PUBLIC MEETING – SEPTEMBER 8, 2021

- VI. OLD BUSINESS
 - A. S.L. Chasse Steel Site Plan 201 Robinson Road
 SP# 03-21 Map 105/Lot 017-002
 Purpose of Plan: to show a proposed industrial building totaling 22,500 SF and associated parking.

Re: Town of Hudson Planning Board Review
SL Chasse Steel Site Plan, Robinson Road
Tax Map 105 Lot 17-2; Acct. #1350-532
Reference No. 20030249.2020

GRADING, DRAINAGE & UTILITY PLAN

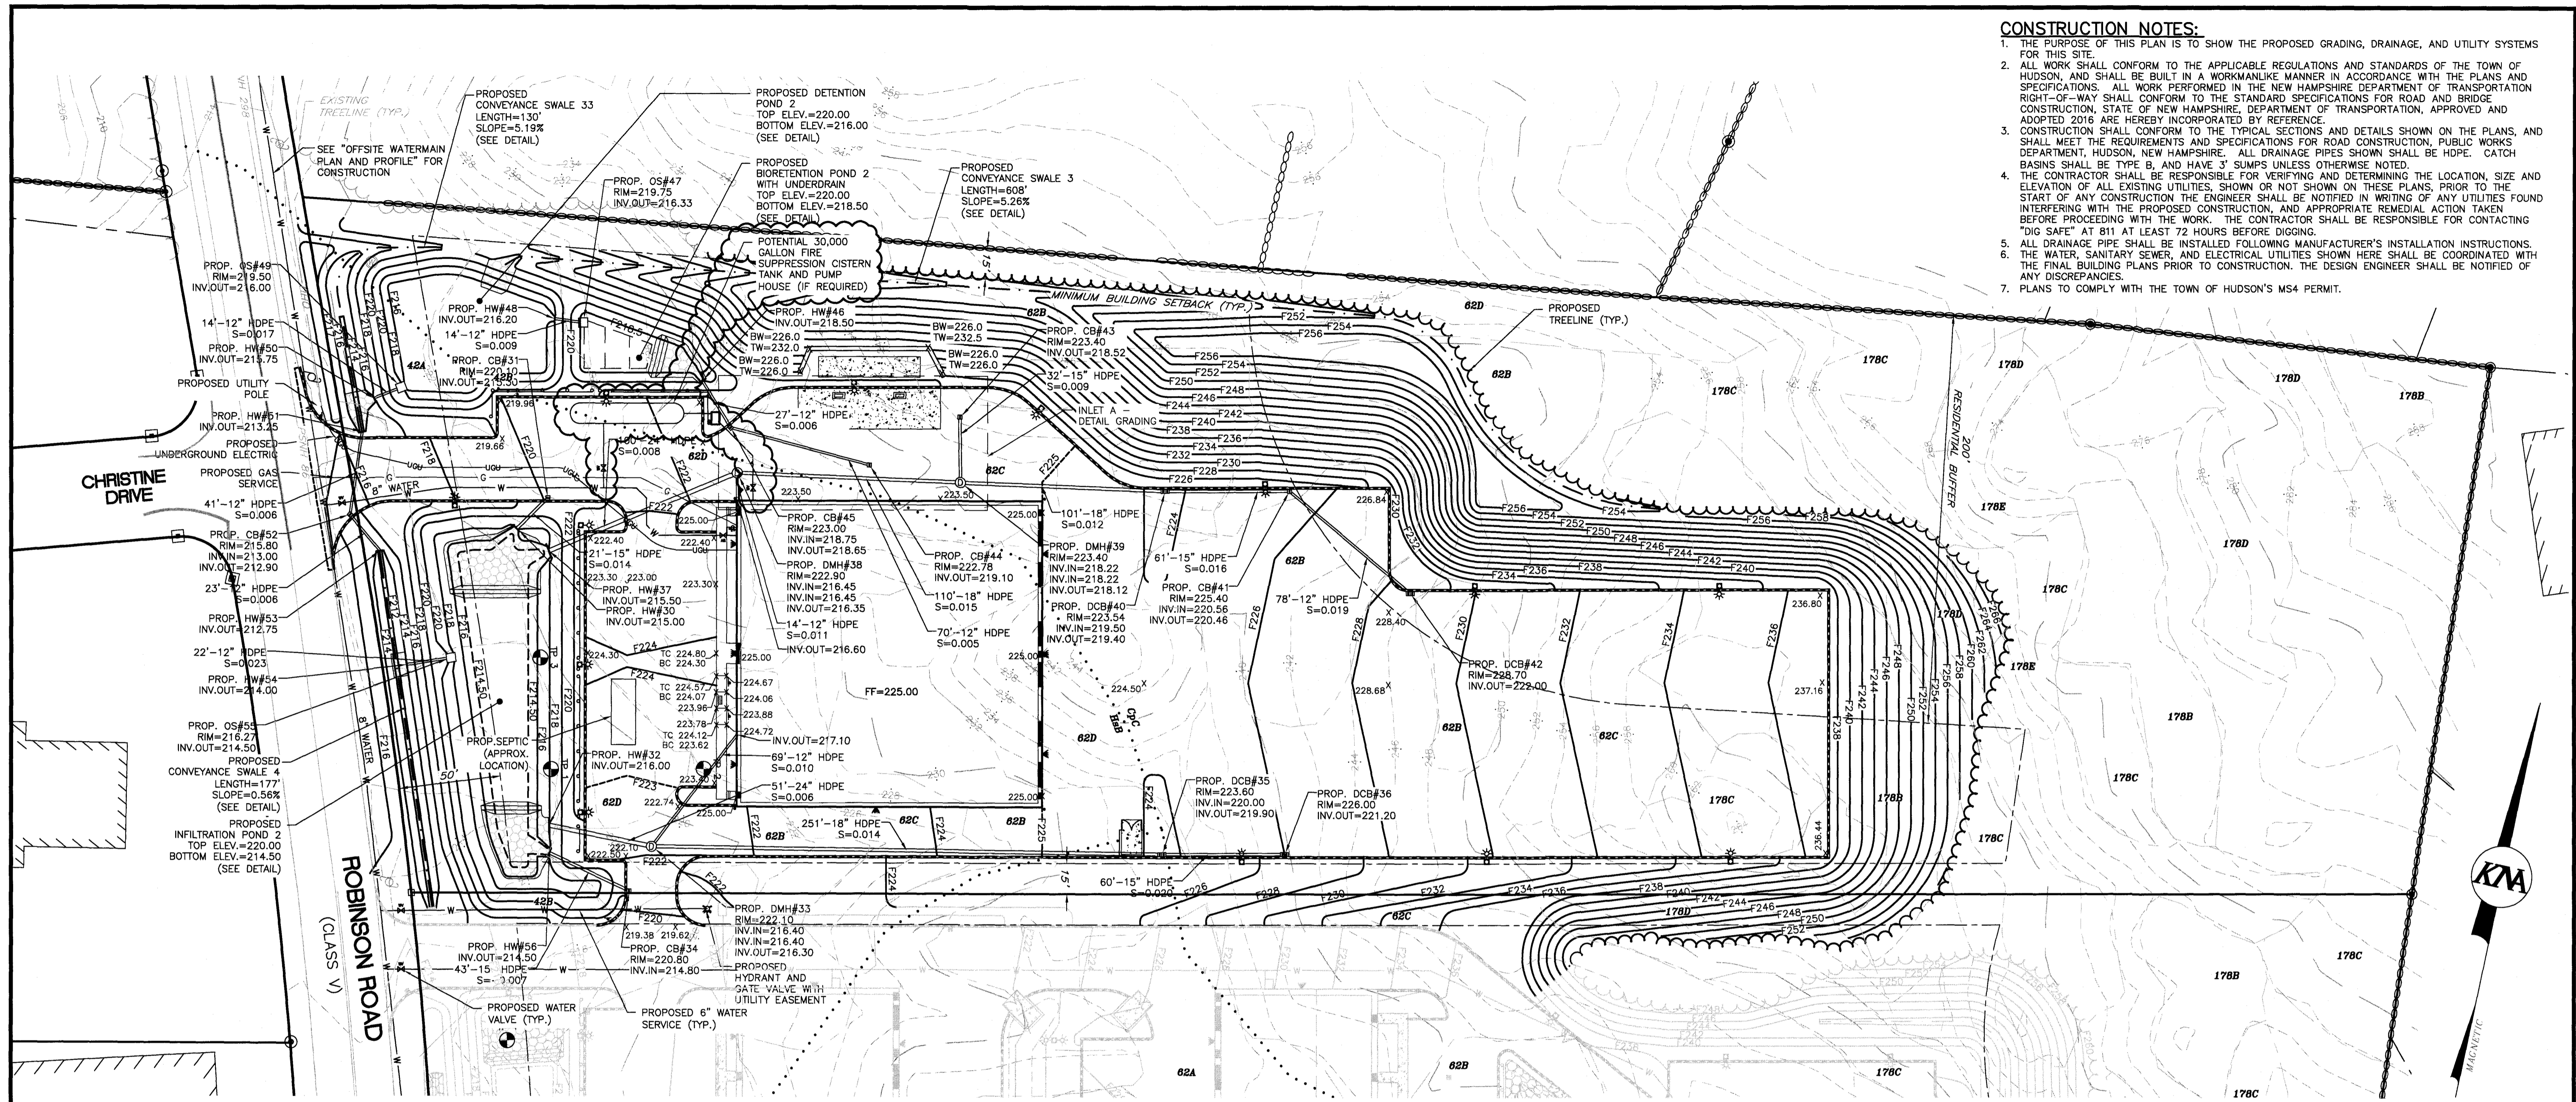
Note: Included in this packet is revised Sheet 5 showing fire suppression storage tanks.

Additionally, during final design of the sprinkler systems for the respective buildings, if a “quick-response” system is designed and built; further forgiveness on the fire flow may become available. This has the potential to reduce the needs described above. Accordingly, this may mean starting the building permit review prior to recording the final Mylar in order to determine the final tank design.

A revised plan sheet has been provided showing proposed tank locations, if necessary.

6. The final design and size of the fire suppression water supply tanks shall be subject to the Fire Department’s determination. The final Plan will reflect the needs identified during the building permit review process, which may begin prior to recording of the Plan. A building permit will not be issued until the Plan is recorded.

SIGHT DISTANCE PLAN
SCALE: 1" = 40'

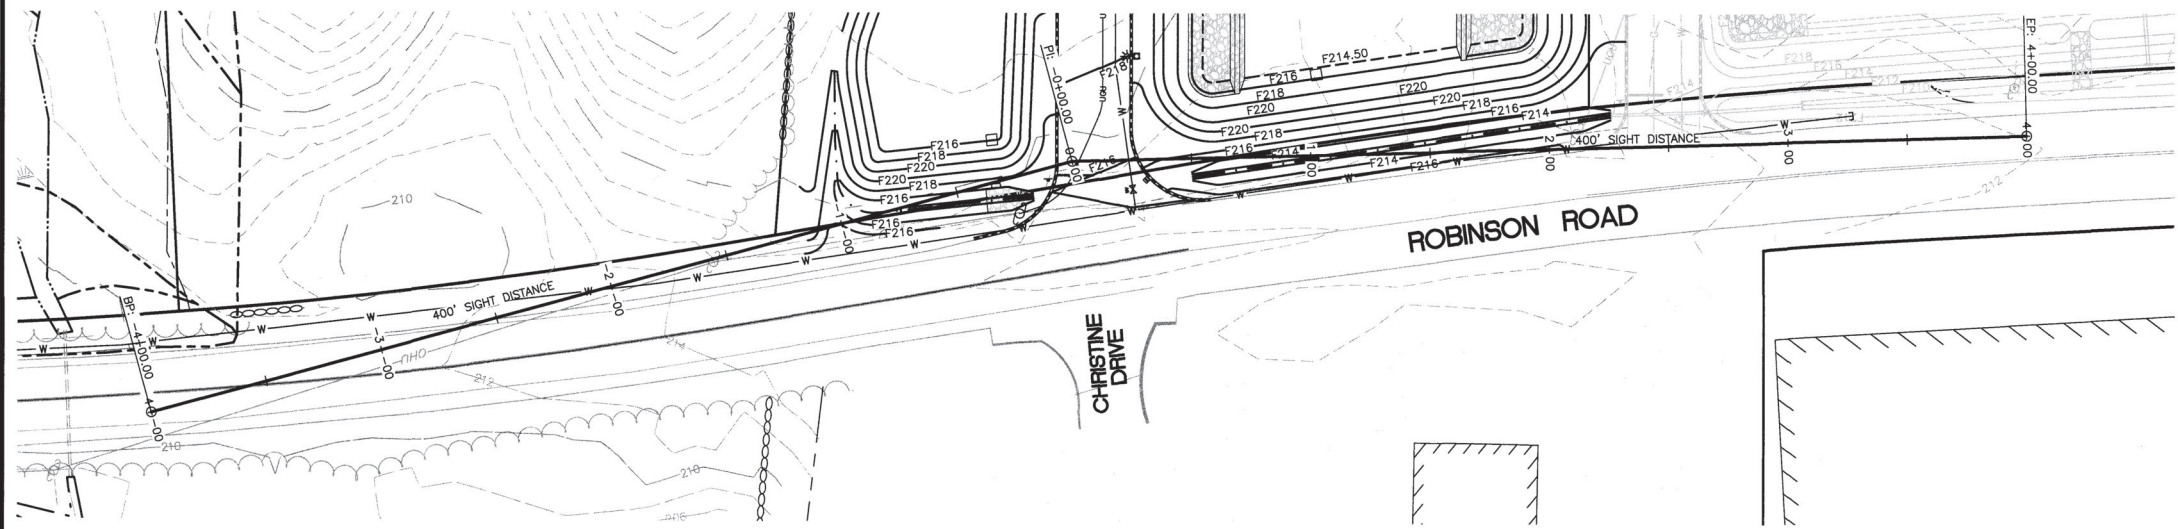
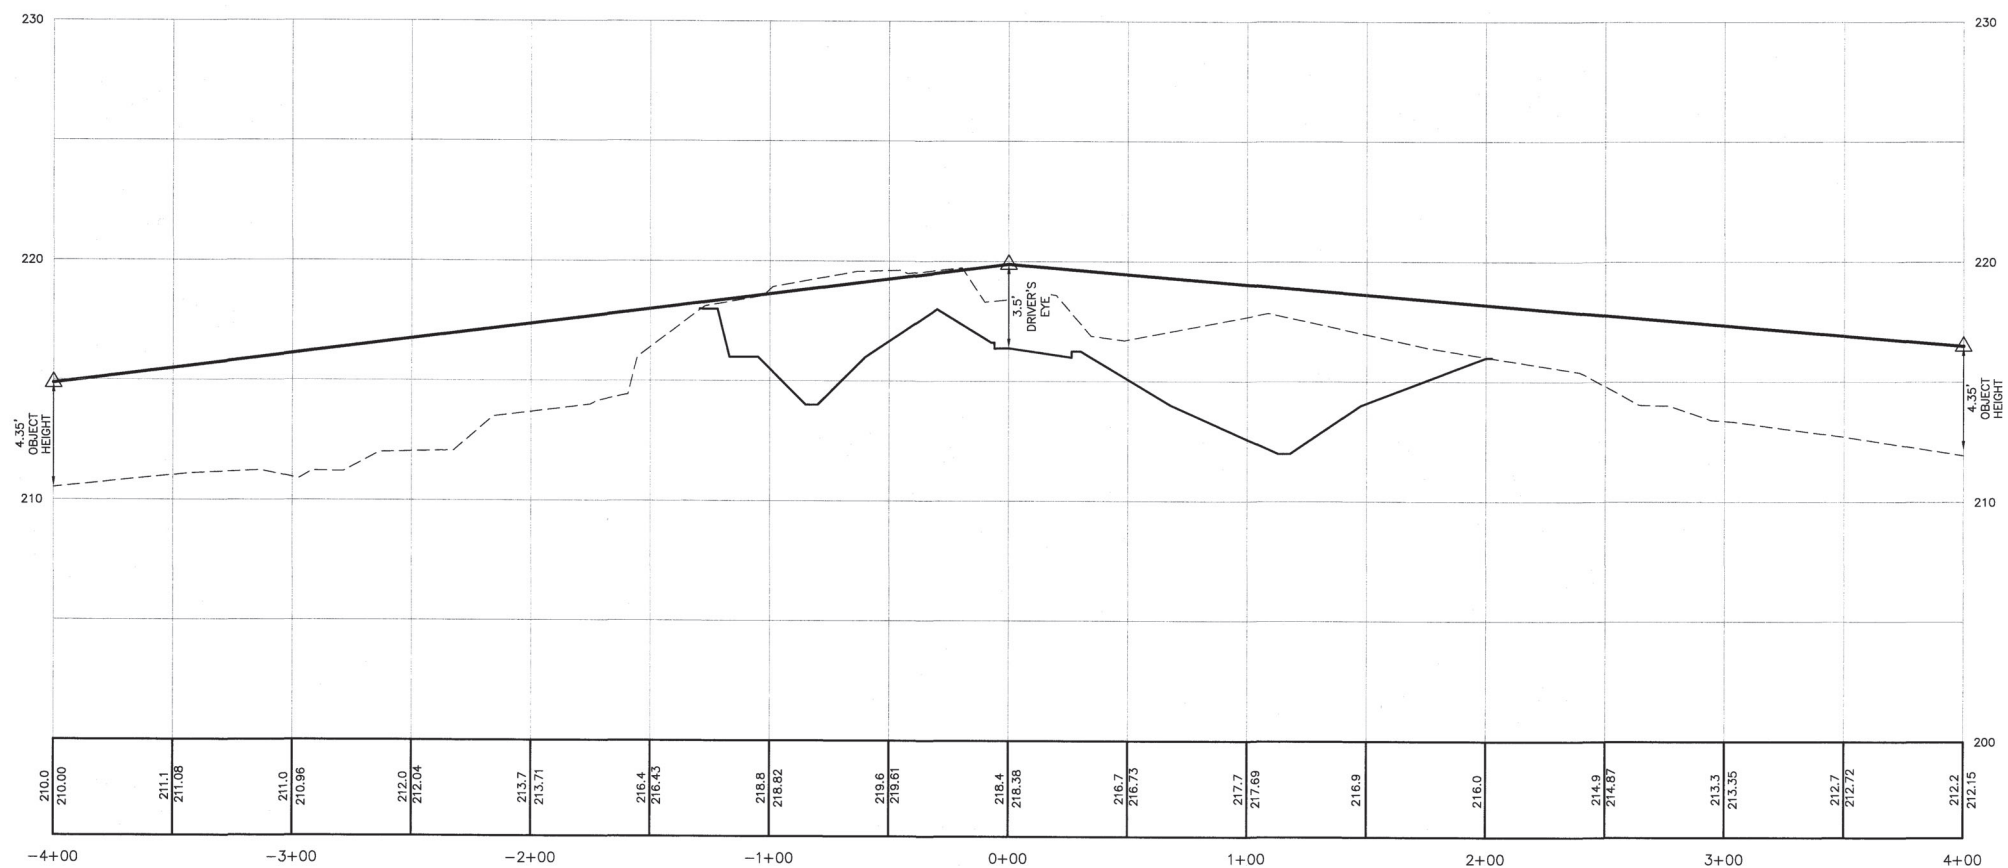
- a. **Former/Current Fuss & O'Neill Comment:** HR 193.10.E. The applicant has shown sight distances of 400 feet for the proposed driveway on the plan set. We note that the site line is very close to the existing grade at Station 1+00 and that it does not take into account snow or vegetation. The applicant should review the need to modify this area to better account for seasonal obstructions.
